Access Compliance Report

Public Rights-of-Way

(Curb Ramps)

Intersection ID: 8727	Main Street: NEWLAND_RD	Cross Street: SAMUEL_ST	Location: E
ADA ID: 42EB125DE0BB	Ramp Type: PerpDiag	Initial Pass/Fail: Fail	Overall Compliance: No
		Severity Score: 22.5

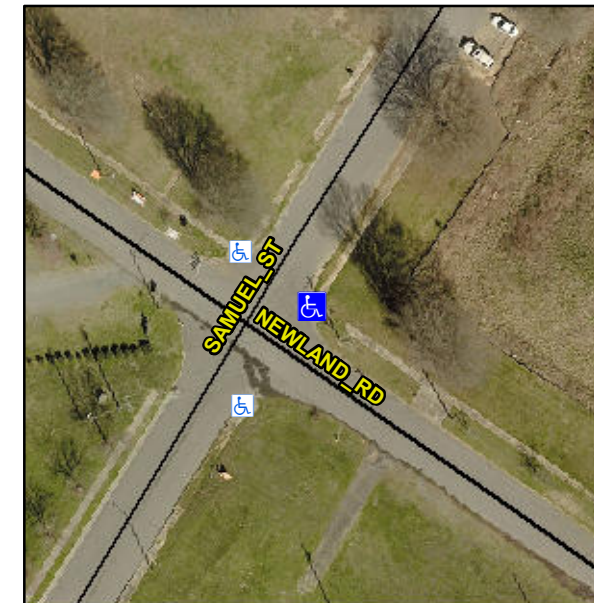
Not Found, R304.5.1, R304.2.2, R304.5.3

Compliance	Description	Data	Compliance	Description	Data
N/A	Ramp Length (in)	62.0	No	Ramp Slope (%)	10.6
No	Ramp Width (in)	43.0	No	Ramp XSlope (%)	2.5
N/A	Flare Type LT	N/A	N/A	Flare Type RT	N/A
N/A	Flare Slope LT (%)	N/A	N/A	Flare Slope RT (%)	N/A
N/A	Flare Traversable LT?	N/A	N/A	Flare Traversable RT?	N/A
N/A	Landing Length (in)	N/A	N/A	DWS Provided?	N/A
N/A	Landing Width (in)	N/A	N/A	DWS Contrast?	N/A
N/A	Landing Slope (%)	N/A	N/A	DWS Length (in)	N/A
N/A	Landing X Slope (%)	N/A	N/A	DWS Full Width?	N/A
N/A	Landing Curb? (Y/N)	N/A	N/A	DWS Offset (in)	N/A
N/A	Shared Landing?	N/A			
N/A	Gutter Ponding?	Yes	N/A	Gutter Slope (%)	N/A
N/A	Gutter Lip Ht (in)	N/A	N/A	Gutter X Slope (%)	N/A
N/A	Painted X Walk1?	No	N/A	Painted X Walk2?	No
	X Walk 1 Direction	To NW		X Walk 2 Direction	To SW
N/A	X Walk 1 Width (in)	N/A	N/A	X Walk 2 Width (in)	N/A
	X Walk 1 Slope (%)	0.4		X Walk 2 Slope (%)	2.4
	X Walk 1 X Slope (%)	0.5		X Walk 2 X Slope (%)	3.5

Remove & Replace Curb Ramp With Two New Directional Ramps or Equivalent.
